TECHNICAL SERVICE BULLETIN

Part #:	VAR-01012017	Engine:	6.0L Powerstroke & VT365 Navistar
Date:	01/14/2021	Title:	6.0L Variation

FIRST STYLE BRANCH

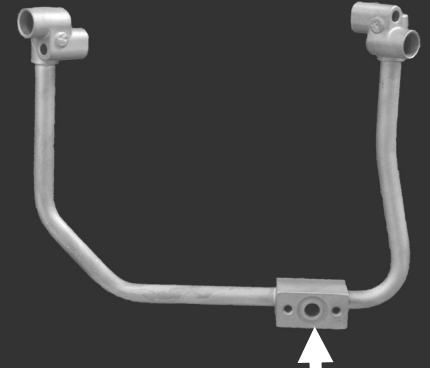
THREADED STAND PIPE CONNECTION PART #1840550C1
